## Secop Single Pack Boxes

## Secop Boosts Single Packs Pallet Load

Fig.1 New Secop Single Pack box

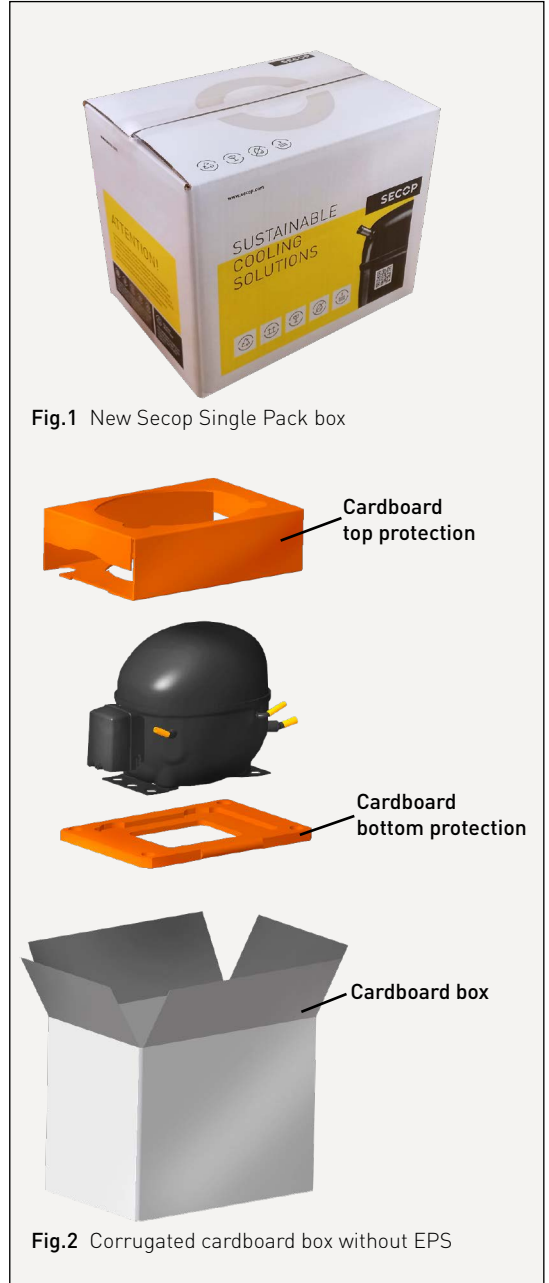
Our new Single Pack boxes (see Figure 1) feature a new layout with a label that is visible from two sides (see page 3). Different box sizes are available depending on the compressor platform.

The corrugated cardboard box and its inner corrugated cardboard parts serve as a stable cushion for any product it carries during shipping and handling. It is easy to recycle, biodegradable and therefore sustainable. The new Single Pack Box design does not contain any EPS (expanded polystyrene). The light weight and flexibility are further advantages of this packaging solution (see Figure 2).

Fig.4 Pallet with 42 Single Packs (new layout)

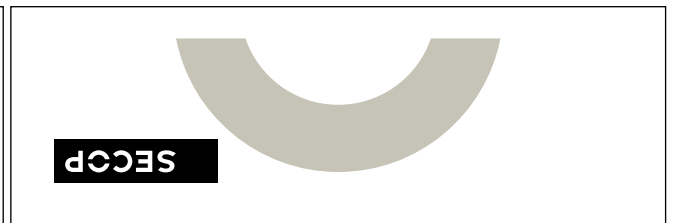
Due to container weight limitations prescribed by international regulations, Secop reserves the right to use the maximum quantity of 42 units per pallet where necessary. More details will be agreed at the time of shipping with Secop's delivery administrators (see Figure 4).

Fig.3 Pallet with 56 Secop Single Packs (old layout)

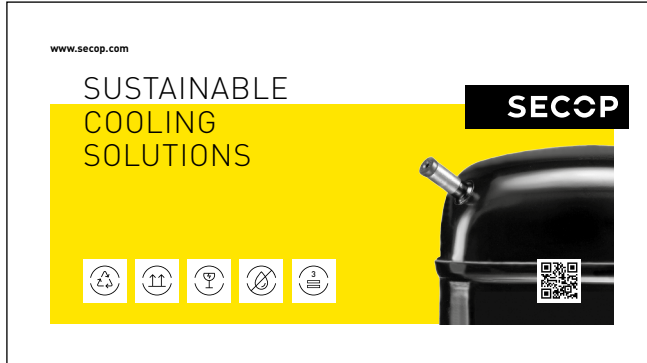
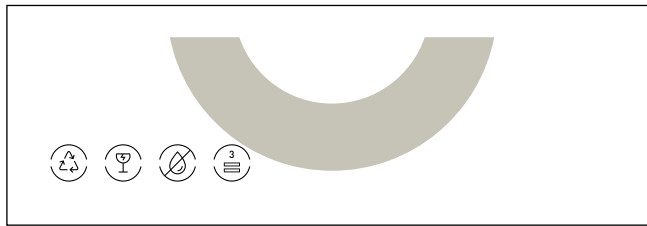
The load per pallet will be increased from the current 42 units to 56 units to optimize loading with less empty space in containers and trucks while also improving the timing of load preparation in our factories.

To ensure safe transport on pallets with higher stacking heights, Secop uses cardboard corners on the top and also on the vertical sides, together with plastic strapping in both directions. (see Figures 3 and 4)

In accordance with internal packaging testing standards, Secop conducted several transportation, rigidity and dragging tests. To obtain the most accurate results, compressor series with the highest weight on the pallets were selected. The pallets were secured with cardboard corners, plastic film and double strapping across the pallet (see Figures 3 and 4).
